HISTORIC AND DESIGN REVIEW COMMISSION

Agenda Item No: 20

HDRC CASE NO: 2016-020
ADDRESS: 139 E COMMERCE ST
141 E COMMERCE ST
143 E COMMERCE ST
106 RIVERWALK
145 E COMMERCE ST
147 E COMMERCE ST
149 E COMMERCE ST
151 E COMMERCE ST
LEGAL DESCRIPTION: NCB 106 BLK LOT 27
NCB 106 BLK LOT 28
NCB 106 BLK LOT 29 & 30
NCB 106 BLK LOT 31
ZONING: D HS RIO-3, D RIO-3
CITY COUNCIL DIST.: 1
LANDMARK: Commercial Building
APPLICANT: KHI, Inc
OWNER: Burgos LP / Uriarte LP
TYPE OF WORK: Demolition with new construction of a mixed use, mid-rise tower
REQUEST:

The applicant is requesting conceptual approval to:

4. APPROACH TO COMMERCE STREET FAÇADE AND RELATIONSHIP TO WITTE AND ESQUIRE

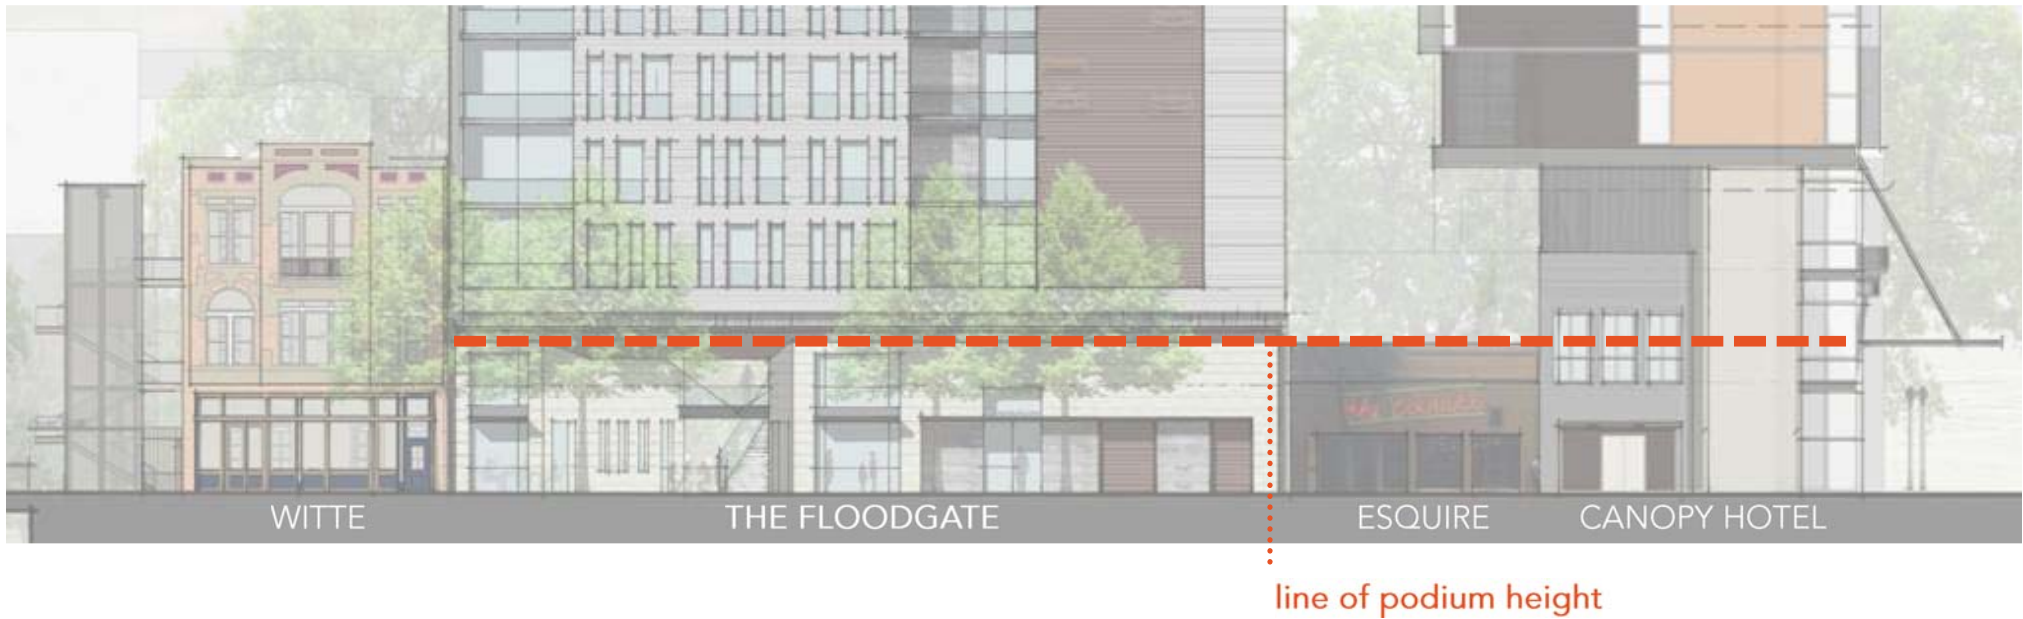
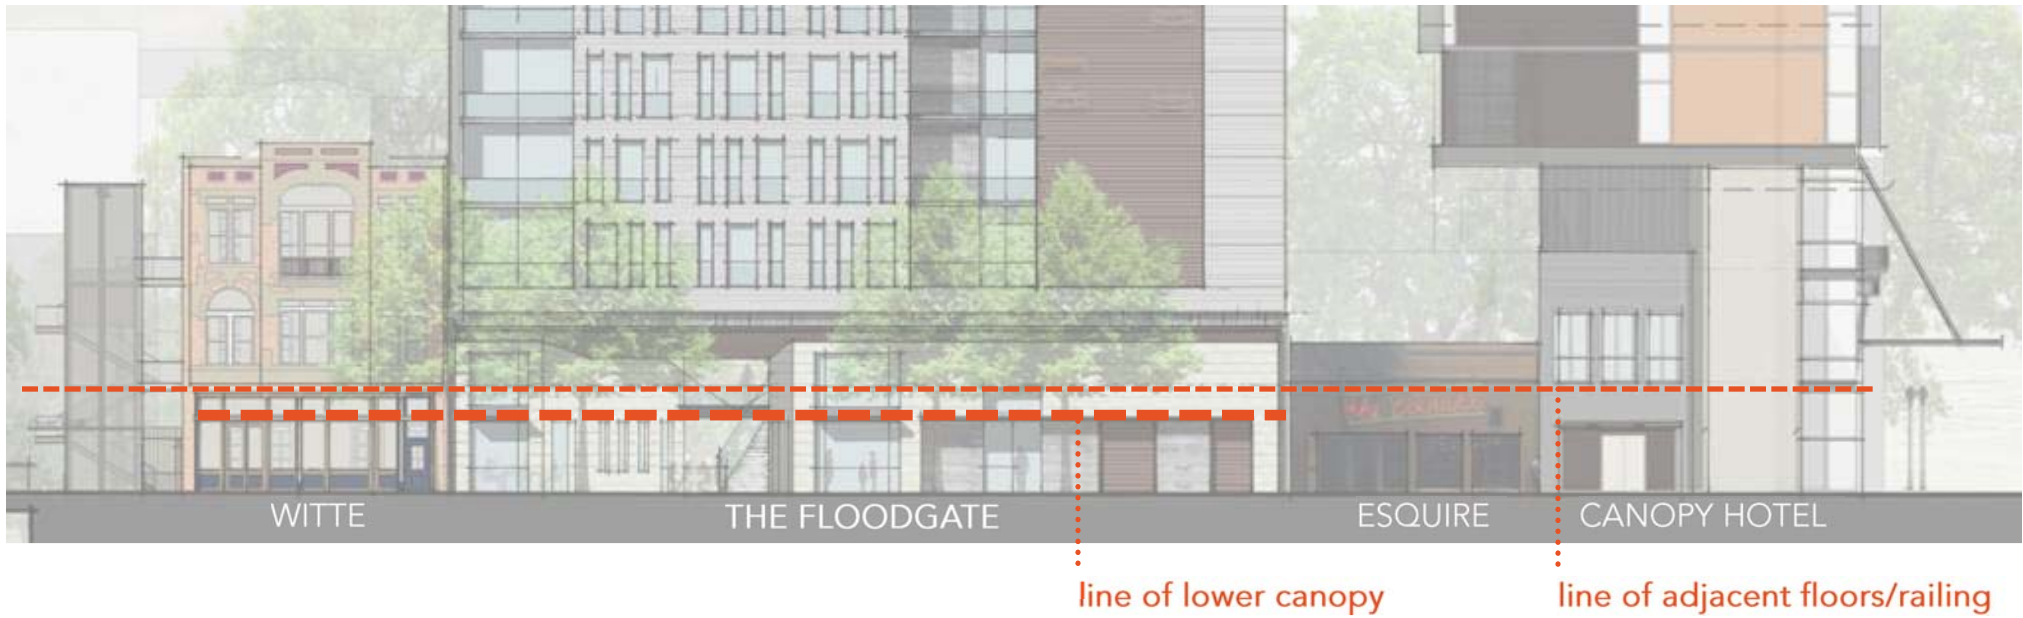
TC: Concerned about uniformity about ~~site plan showing~~ street elevation in respect to neighboring buildings and other elevations. more contemporary materials, and not necessarily stone. Improve on detailing. MG: bring scale down at river level by creating a smaller opening. Size of the aperture - is it too large, how does it read? Removing the walls will alter the feel of the river walk experience.
